SNUPPS

SLNRC 84-0085 FILE: 0278
SUBJ: Callaway Plant Ultimate
Heat Sink Technical
Specification Requirements

Docket No.: STN 50-483

CALLAWAY UHS
RETENTION POND
LEVEL VS VOLUME

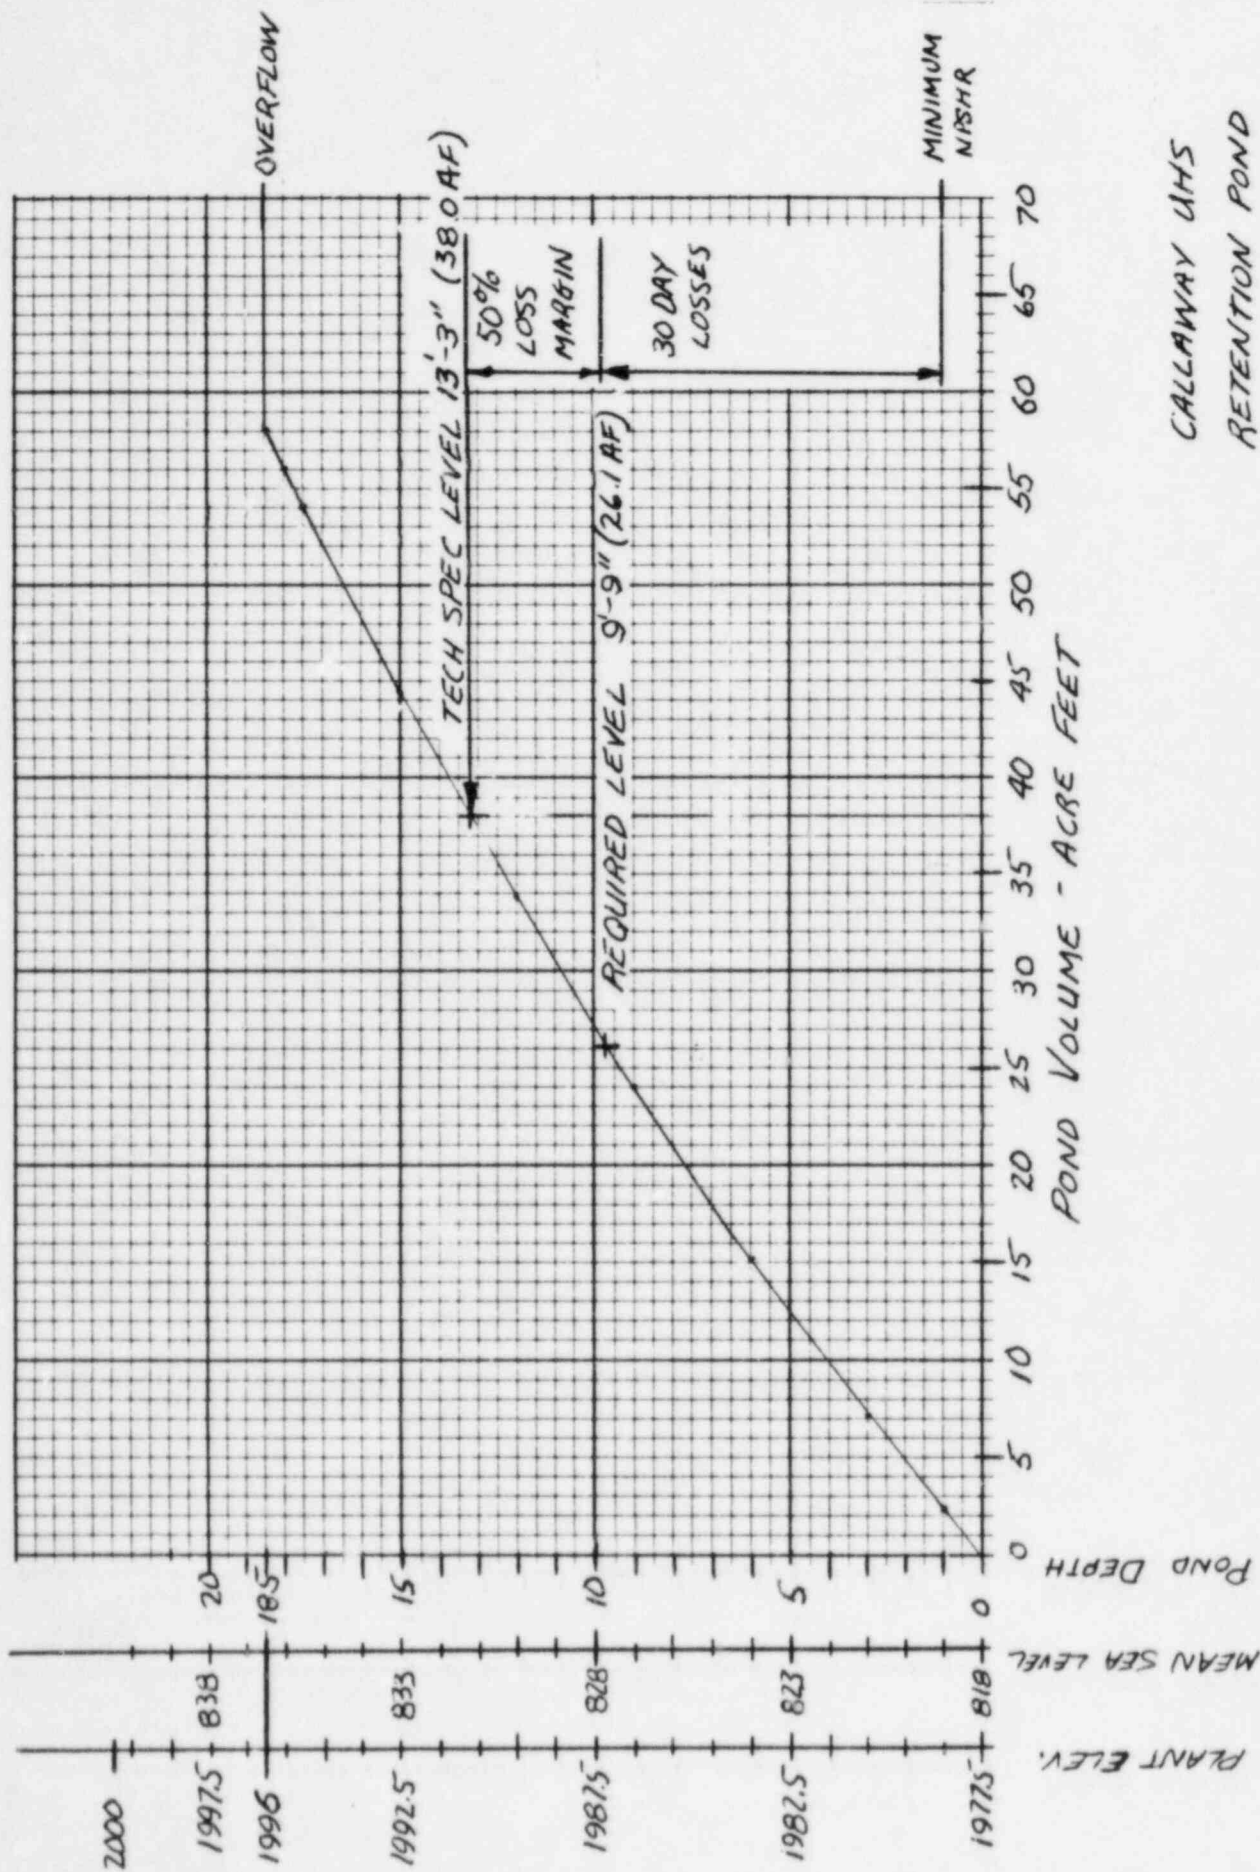
A calculation has been performed to determine the appropriate UHS water level for a single 3425 MWT unit. The calculation used the same conservative analytical methods described in the SNUPPS FSAR and Callaway FSAR Site Addendum for the two-unit calculation. The result of this calculation is a UHS water level of 9.75 ft. To this level, an additional 50% margin has been added to establish a new Technical Specification limit of 13.25 ft. The enclosed figure reflects the results of the calculation for one nuclear unit.
